PLAN COMMISSION AGENDA
January 14, 2019

Eau Claire Plan Commission 1/14/19 Agenda Items

STAFF REPORT

Design Firm License No.

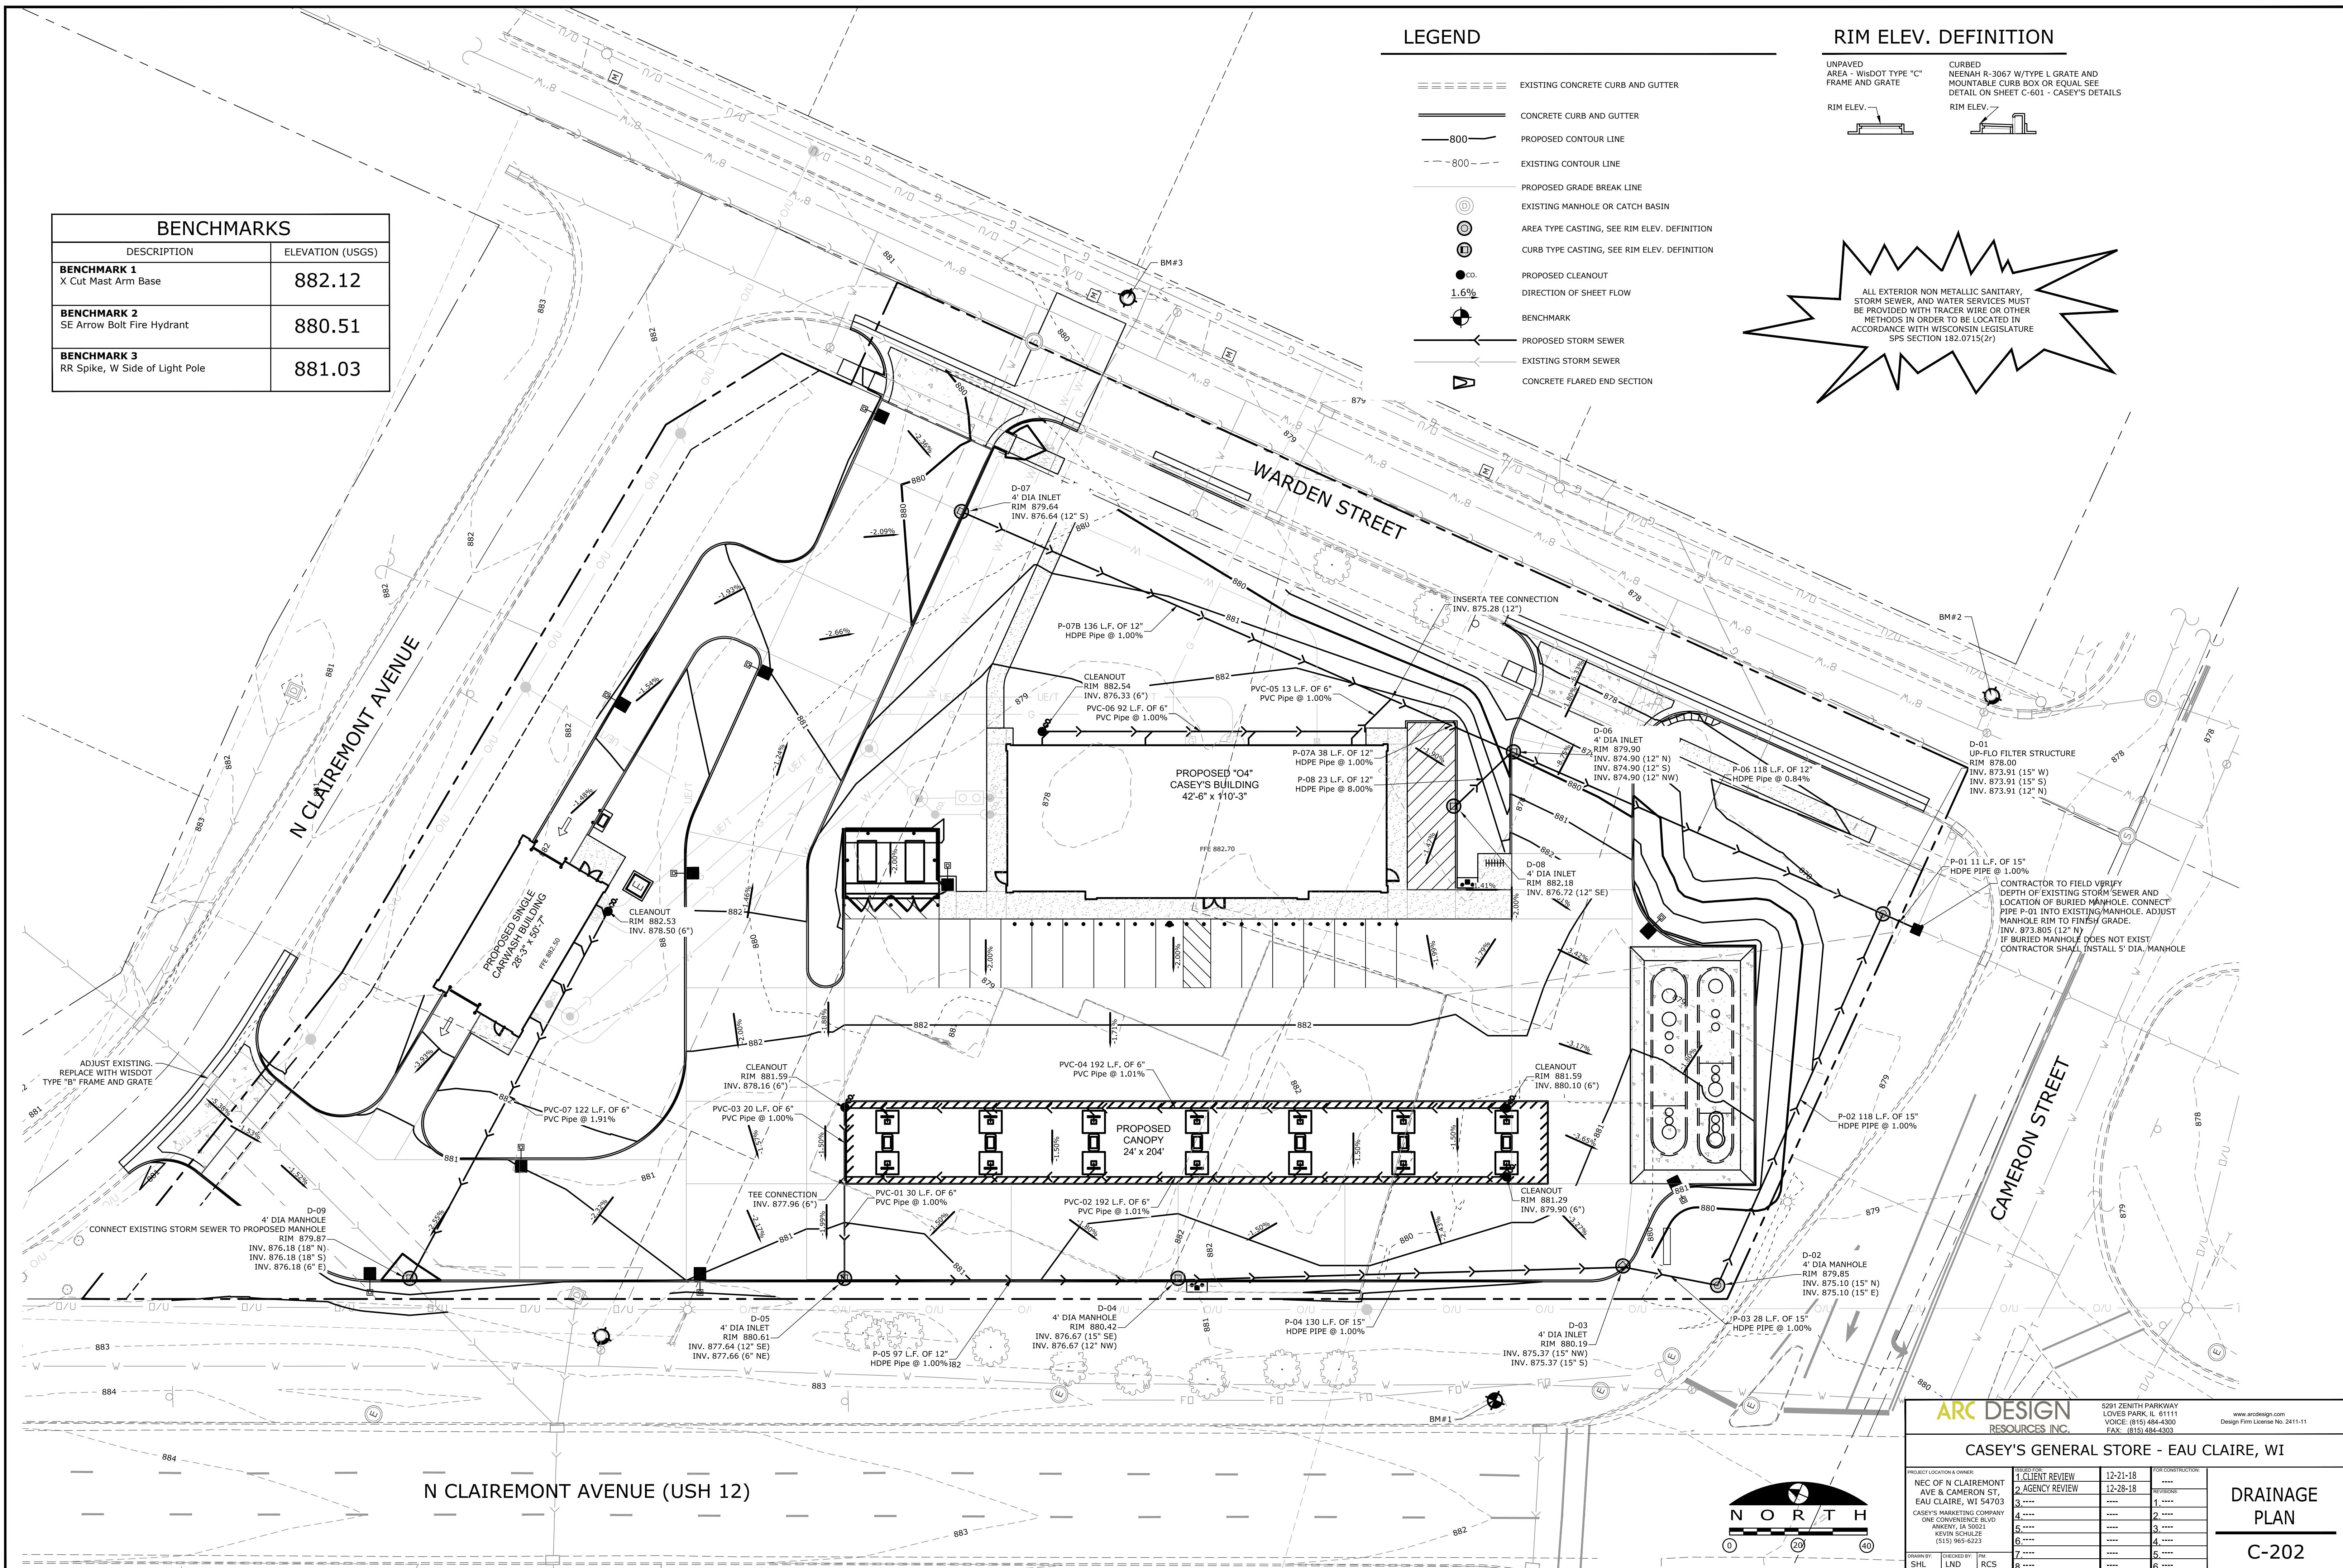
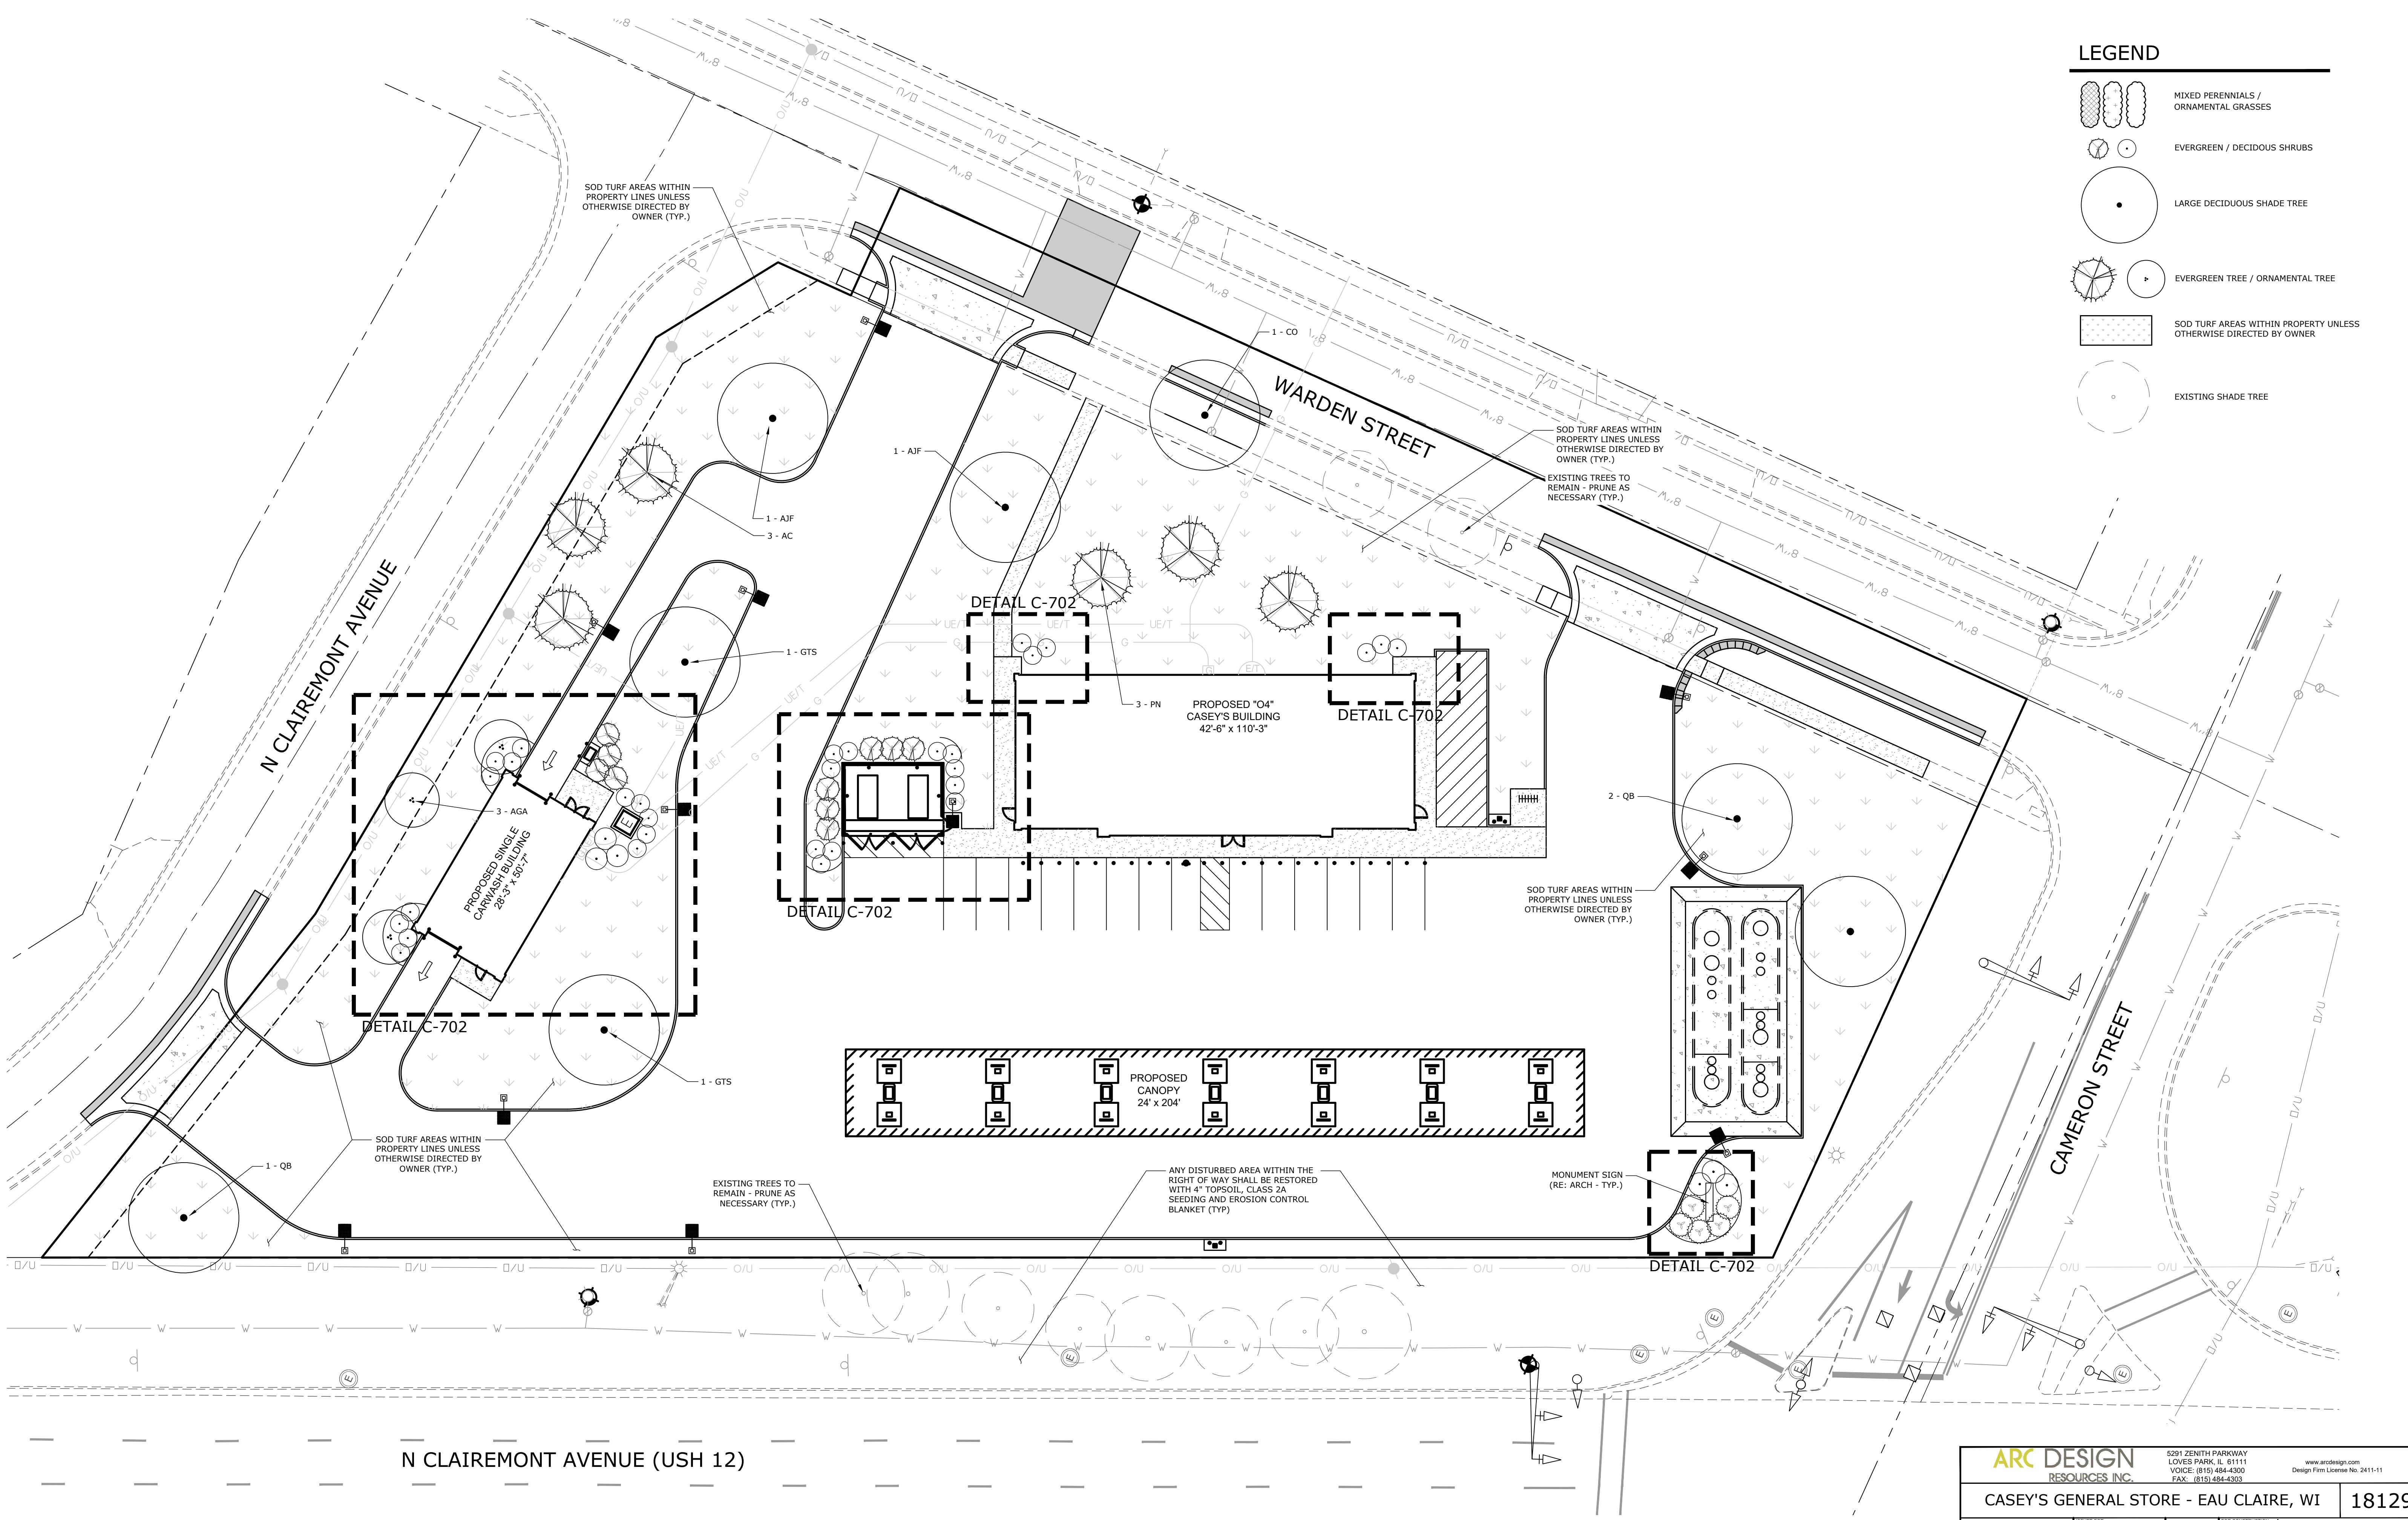
Storm water best management practices (BMP's) are required to improve runoff water quality. A sump and Up-Flo filter are proposed as the water quality BMP's. Materials submitted with the site plan indicate that in this application these units are calculated to remove approximately 45% of Total Suspended Solids. The threshold for redevelopment BMP's identified in NR151 is a 40% reduction in Total Suspended Solids. Detailed specifications must be submitted regarding the Up-Flo filter to verify water quality treatment parameters.

Traffic: The traffic generated by the proposed improvements is expected to change the traffic patterns in the area. An abbreviated Traffic Impact Analysis (TIA) should be performed on the proposed area. The goal of the TIA is to indicate the traffic impacts of the development under average traffic conditions and to identify any improvements needed to provide a level of service (LOS) "C" or better or to maintain the current LOS. WisDOT and the City will work together to review the TIA, as traffic is expected to change at intersections with USH 12 (Clairemont Avenue) as well as on the local street system. A development agreement for construction of required traffic capacity improvements may be required upon completion of the TIA review and if required, will be negotiated as a condition of site plan approval.

The plan calls for two new 35-foot curb cuts on Warden Street and one on North Clairemont Avenue Frontage Road. Curb cuts more than 30 feet require Plan Commission Approval. Section 16.36.120 "Drive Apron width-nonresidential use" of the City Code of Ordinances allows the Plan Commission to waive the 30-foot requirement:

1. City of Eau Claire Engineering Department approval of drainage calculations and drainage plan.
2. Provide a spill prevention plan for the areas where fuel is handled.
3. Plan Commission approval of the proposed 35-foot wide driveway width. (Approval of the site plan will be considered approval of the proposed 35-foot wide driveway approach. No additional actions will be required.)
4. City of Eau Claire Engineering Department approval of a Traffic Impact Analysis (TIA) following the WisDOT Initial Review (IR) process. Based on the results of the IR, the scope of the TIA will be developed with input from both the City and WisDOT.
5. Enter into a Development Agreement for Traffic Capacity Improvements, as determined by the Traffic Impact Analysis.
6. Ground sign will need to be moved to meet the proper setbacks and is reviewed with a sign permit.
